STERLING RANCH PHASE 2

PRELIMINARY GRADING PLAN

V1_Grading Plan.pdf Markup Summary

SHEET 6 OF 17

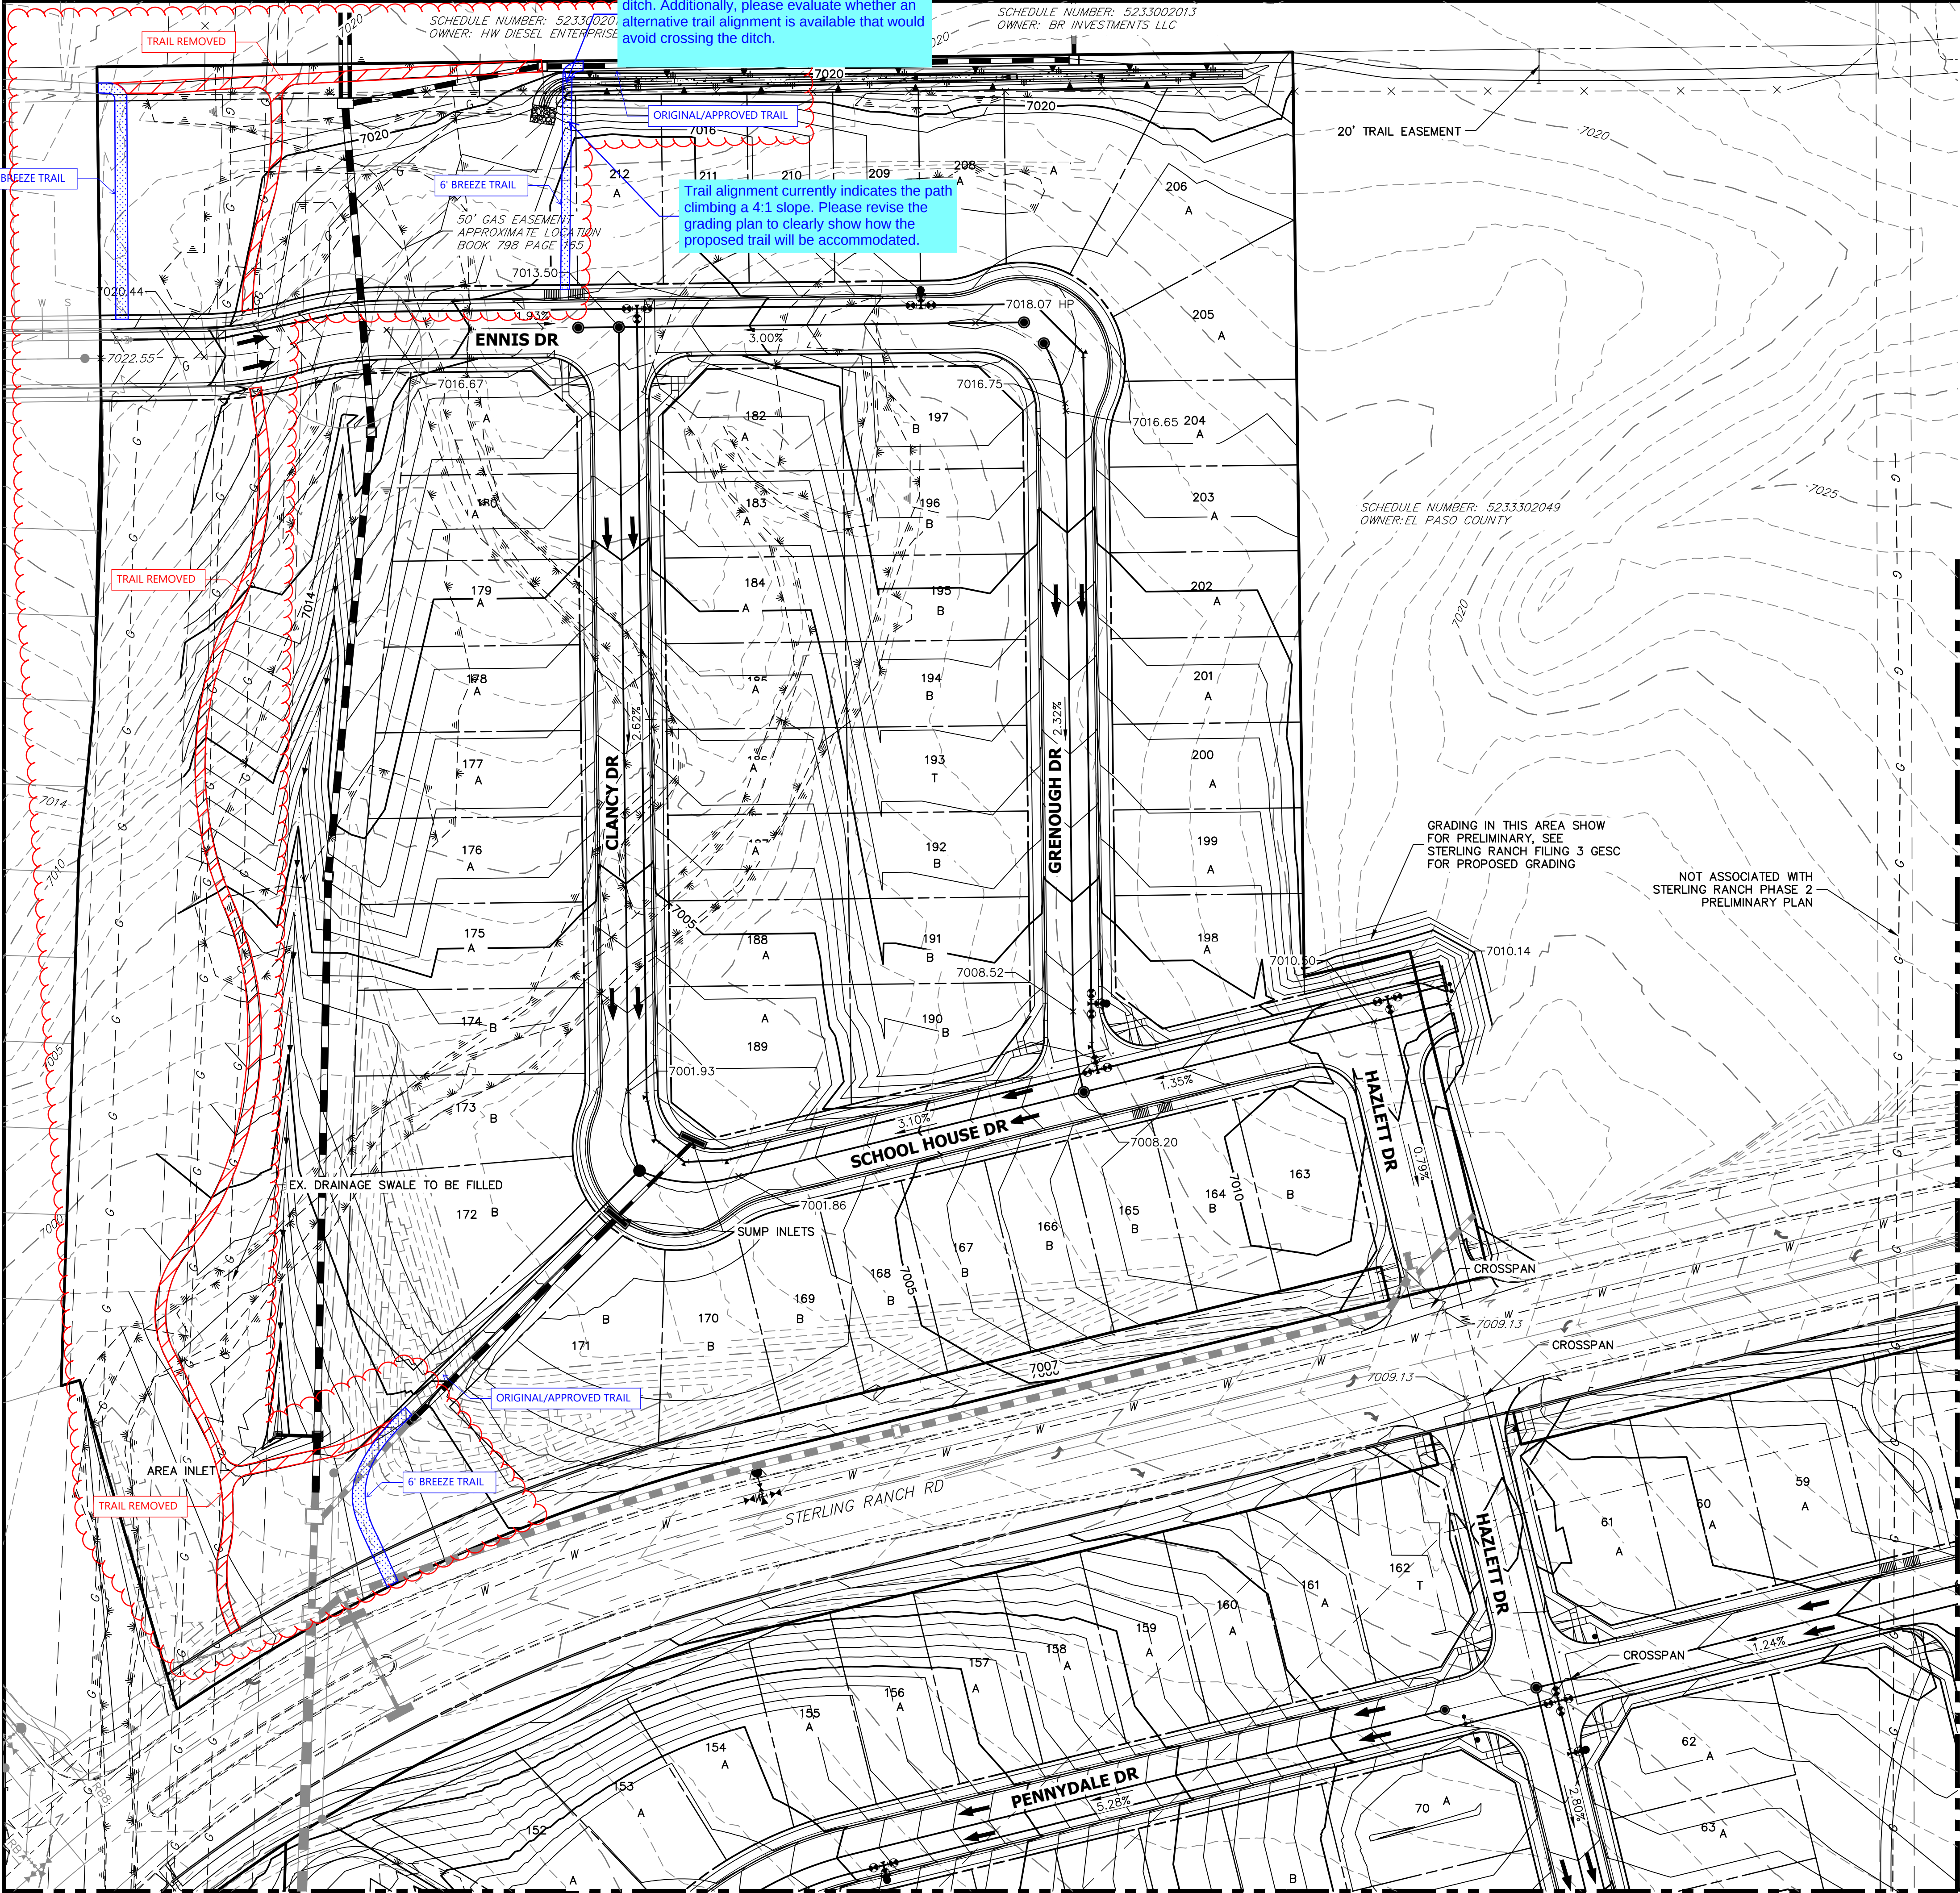
Subject: Callout Page Label: [1] 6 Preliminary Grading Plan - preliminary grading plan - 1 Author: Laura Besler Date: 7/22/2026 8:49:24 AM Status: Color: Layer: Space:	Please provide details demonstrating how the 6-foot breeze trail will cross the FSD overflow ditch. Additionally, please evaluate whether an alternative trail alignment is available that would avoid crossing the ditch.
	Subject: Callout Page Label: [1] 6 Preliminary Grading Plan - preliminary grading plan - 1 Author: Laura Besler Date: 7/22/2026 8:40:57 AM Status: Color: Layer: Space:	Trail alignment currently indicates the path climbing a 4:1 slope. Please revise the grading plan to clearly show how the proposed trail will be accommodated.

STERLING RANCH PHASE 2		H-SCALE	1"=50'	No.	REVISION	BY	DATE
		V-SCALE	N/A				
PRELIMINARY GRADING PLAN		DATE	09/10/21				
		DESIGNED BY	AAM				
		DRAWN BY	CJD				
		CHECKED BY					
SHEET	8	OF	17				
JOB NO.	25188.02

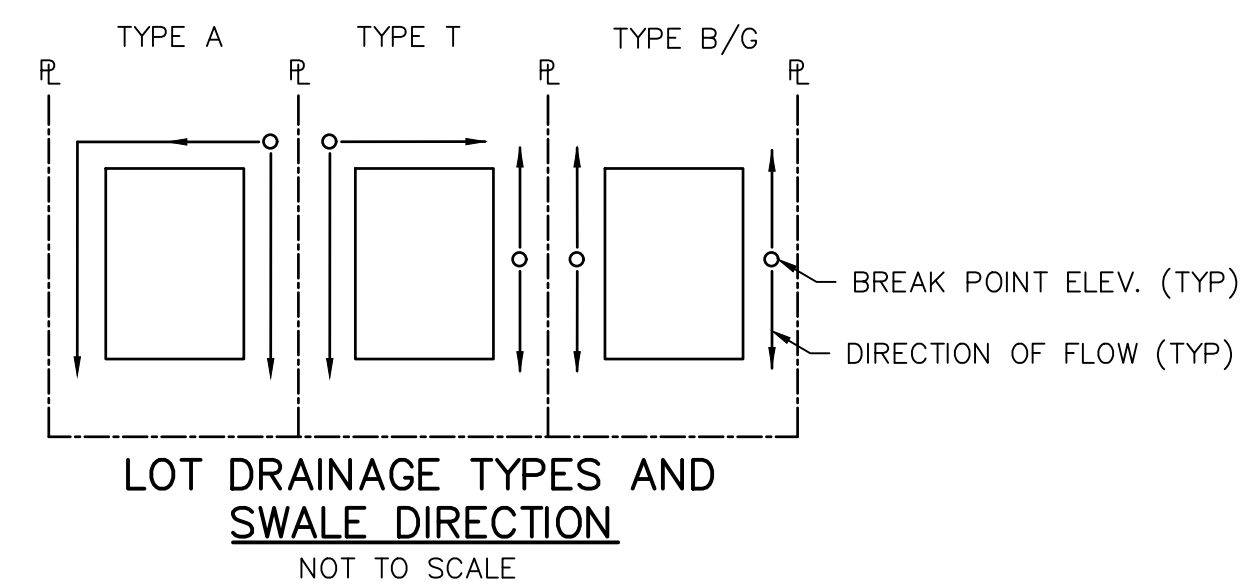
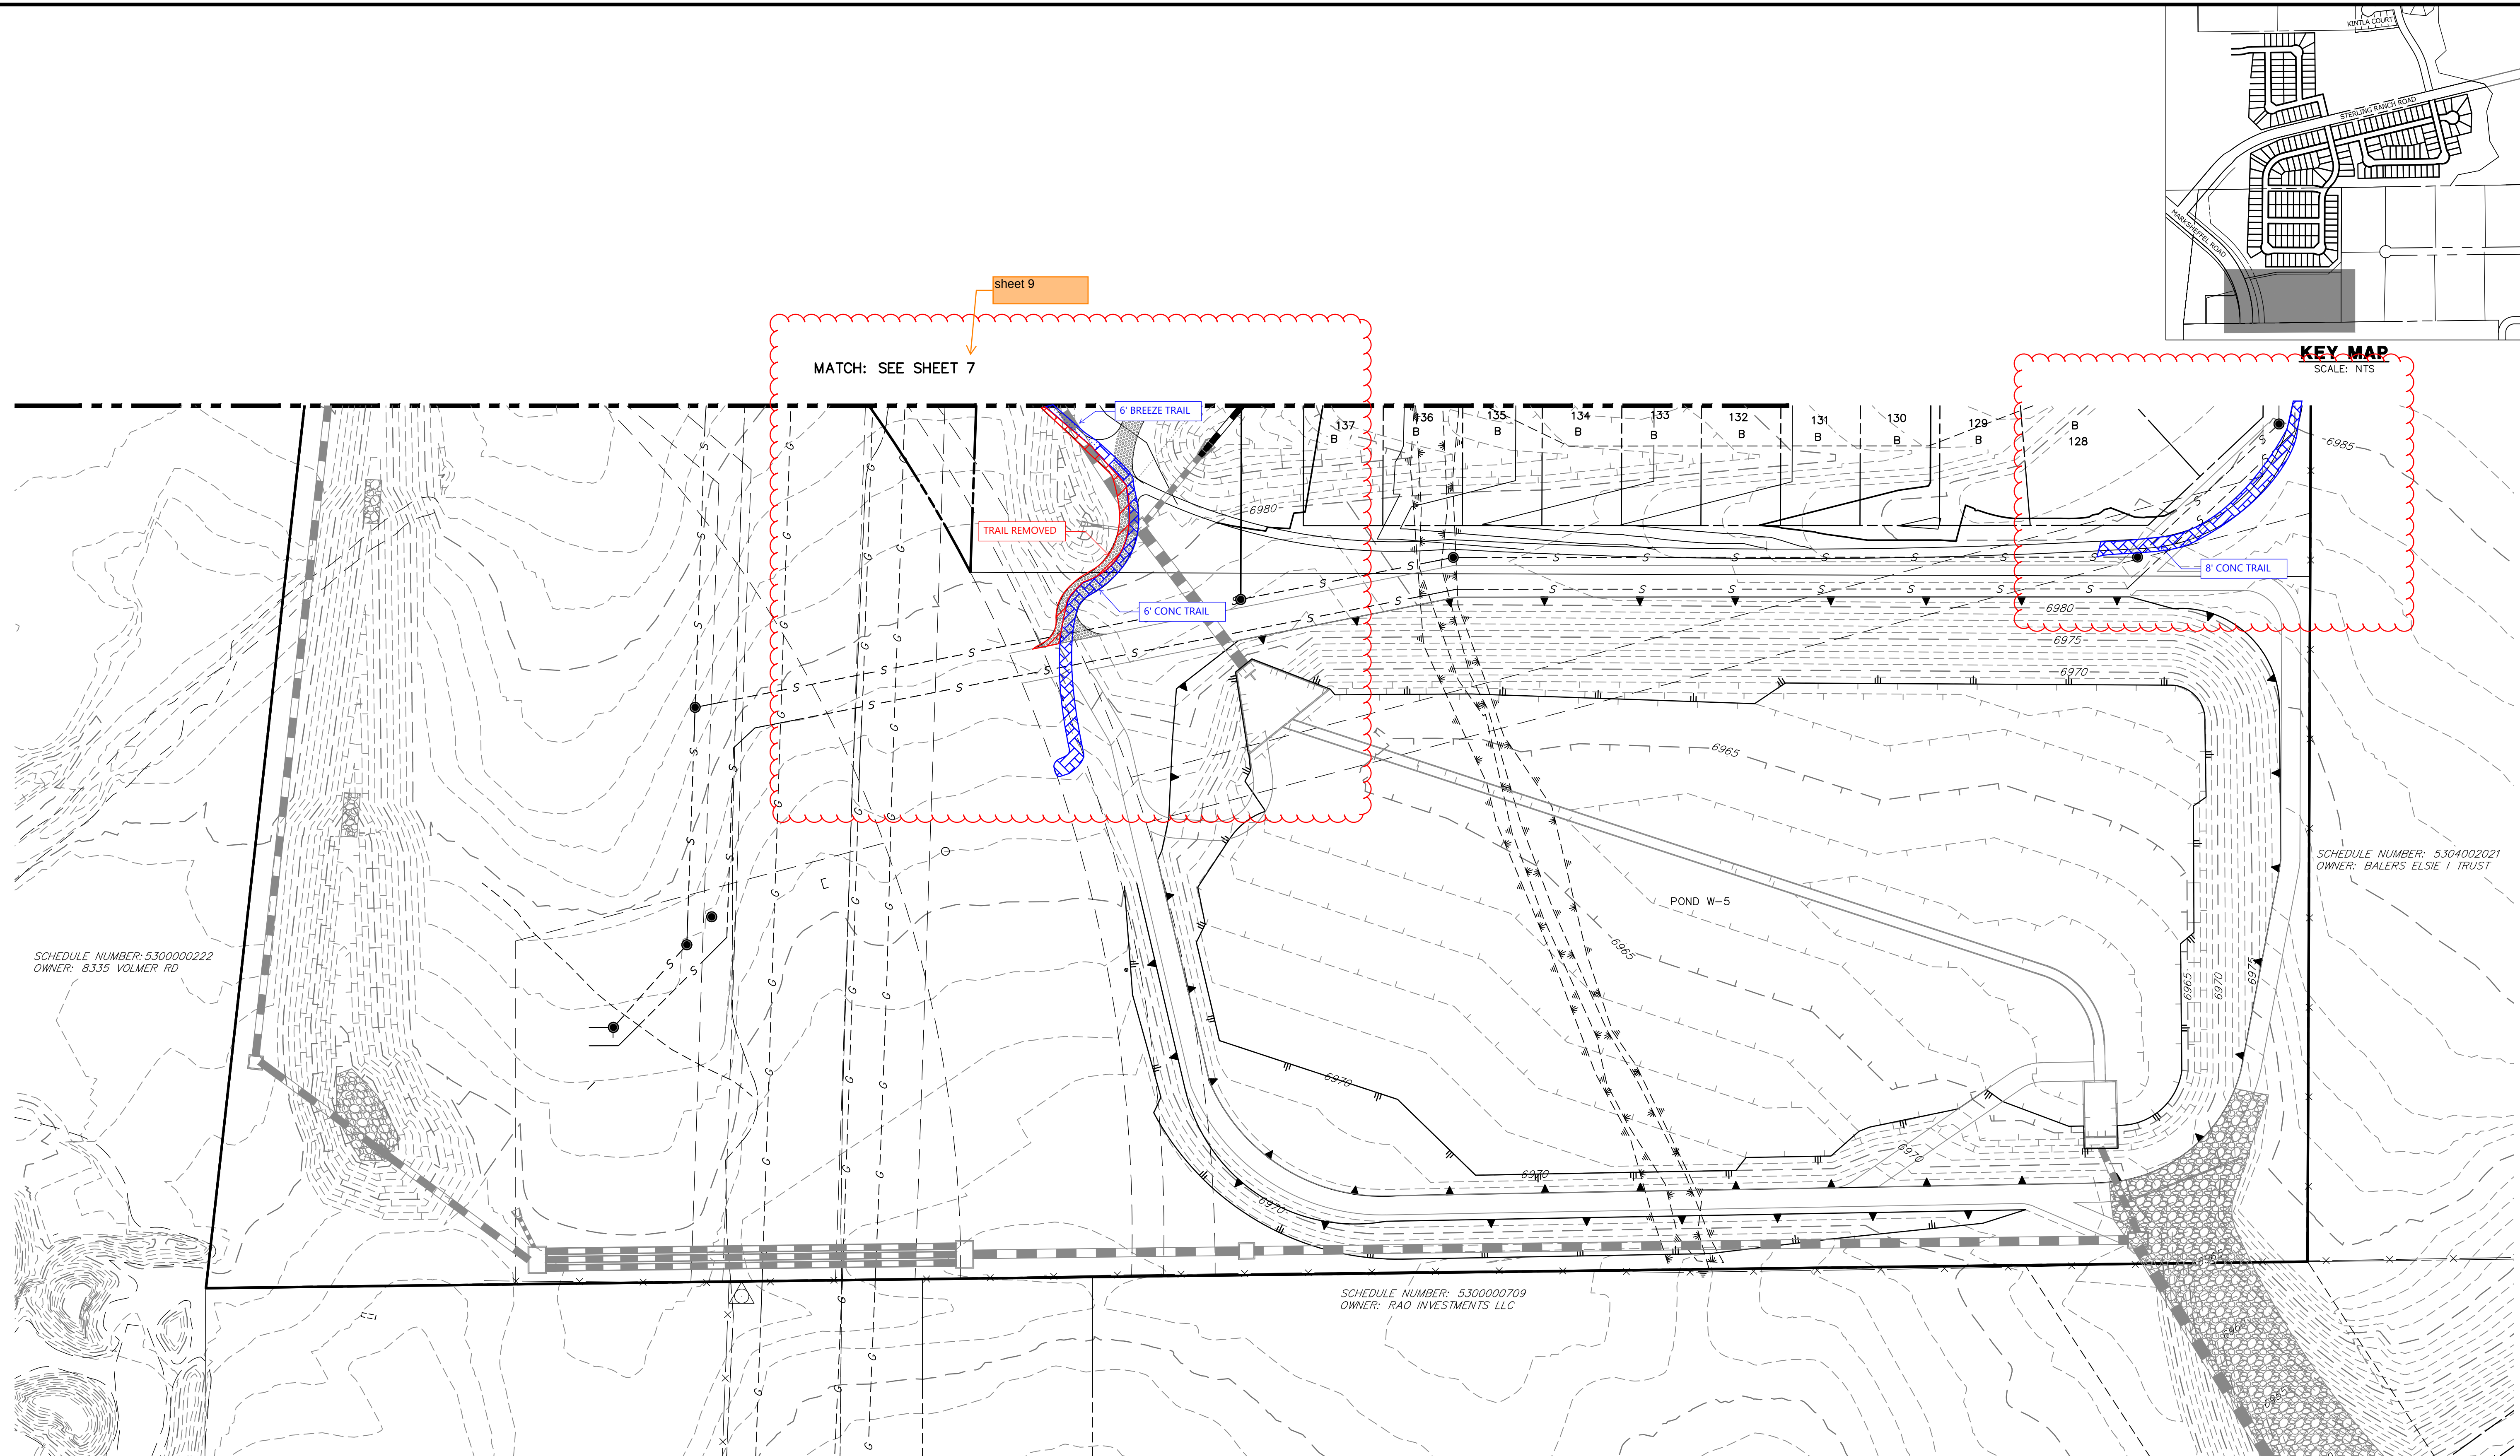
show trail revisions on
this sheet that are
shown on the next sheet
